STAFF ANALYSIS

Case No.:	Z-21-1244669	Agenda #: N3
Location/ Address:	The north side of Jamieson Place and the west side of Market Street, at 3720 Jamieson Place in Clarkston, Georgia.	Commission District: 4 Super District: 6
Parcel ID:	18 067 03 011	
Request:	To rezone properties from R-85 (Residential-Medium Lot-85) to RSM (Small Lot Residential Mix) District to construct single-family attached townhomes.	
Property Owner:	Jose Ramos	
Applicant/Agent:	Amanda Woodruff	
Acreage:	.44	
Existing Land Use:	Vacant Single-Family home and accessory building.	
Surrounding Properties:	Apartments (Fox Trail Apartments) to the west, a place of worship to the south across Jamieson Place (Masjid Al-Momineen of Stone Mountain), and single-family detached homes to the north and east.	
Adjacent Zoning:	North: NA City of Clarkston South: OIT and R-85 East: NA City of Clarkston West: NA City of Clarkston	
Comprehensive Plan:	SUB (Suburban)	Consistent <input checked="" type="checkbox"/> Inconsistent <input type="checkbox"/>

Staff Recommendation: FULL CYCLE DEFERRAL

ZONING EXHIBIT FOR
JAMESON PLACE

ZONING EXHIBIT

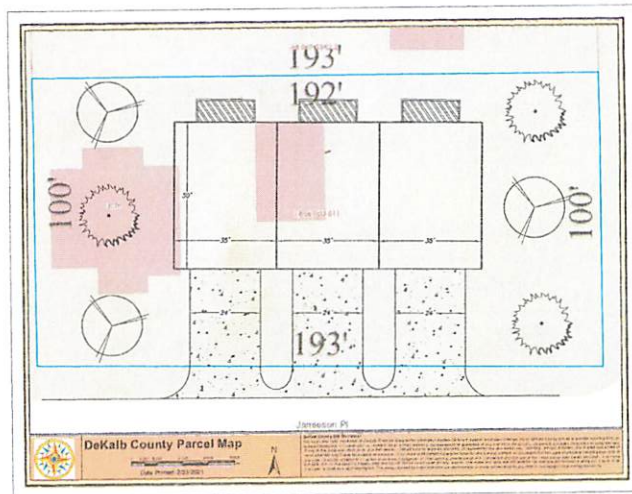
STANDARD	RSM REQUIREMENT	EXISTING/PROPOSED	COMPLIANCE
MAX DENSITY	4-8 units per acre	6.68 units per acre with enhanced open space and public art density bonus.	Undetermined. The site plan needs to clarify what type of density bonuses are being provided to qualify for proposed densities above four units per acre as required in Article 2 of the zoning ordinance.
LOT WIDTH	25 feet	Not indicated. Applicant has not indicated if these are fee-simple lots or condos.	Undetermined based on concept plan. Non-compliance will necessitate variances.
LOT AREA	1000 s.f.	Not indicated. Applicant has not indicated if these are fee-simple lots or condos.	Undetermined based on concept plan. Plan does not indicate if fee-simple lots.
MAX. LOT COVERAGE	70%	Not indicated	Undetermined based on concept plan. Non-compliance will necessitate variances.
FRONT SETBACK	20 feet from Jamieson Place and Market Street	Not indicated	Undetermined based on concept plan. Non-compliance will necessitate variances.

REAR SETBACK	20 ft.	Not indicated	Undetermined based on concept plan. Non-compliance will necessitate variances.
SIDE SETBACK	0 ft	0 feet	Yes

SIDEWALKS AND STREETSCAPING	5-ft. sidewalk and 6-ft. landscape strip, with street trees 30 ft. on center along Jamieson Place and Market Street frontage.	Not shown on plan	No. Non-compliance will necessitate variances.
STREET LIGHTS AND PEDESTRIAN LIGHTS	Street lights shall be installed along public right of way within the landscape strip spaced at a maximum distance of 100 ft on center. Pedestrian lights shall be installed along public right of way at a maximum distance of 40 ft on center.	Information not provided	No. Non-compliance will necessitate a variances.
INTERNAL SIDEWALKS	Pedestrian access shall be provided from all parking areas directly to a public sidewalk.	Internal sidewalks not shown on plan	No. Non-compliance will necessitate variances.

1. *The plan needs to clarify what density bonuses are being provided to justify the proposed 6.8 dwelling units per acre as required by Article 2 of the zoning ordinance. Additionally, the plan needs to indicate if the proposed units are fee-simple or a condominium form of ownership; one fee-simple lots would qualify for the provision of density bonuses.*

2. *The plan needs to provide sidewalks and street trees along Jamieson Place and Market Street as well as 20% open space as required by the zoning ordinance. The plan needs to show compliance with minimum building size, minimum building setbacks, and other requirements of the RSM zoning district as outlined in the compliance table of the staff report.*

3. *The plan should be revised to provide a 20-foot wide undisturbed transitional buffer along the north property which abut single-family residential to provide additional compatibility.*
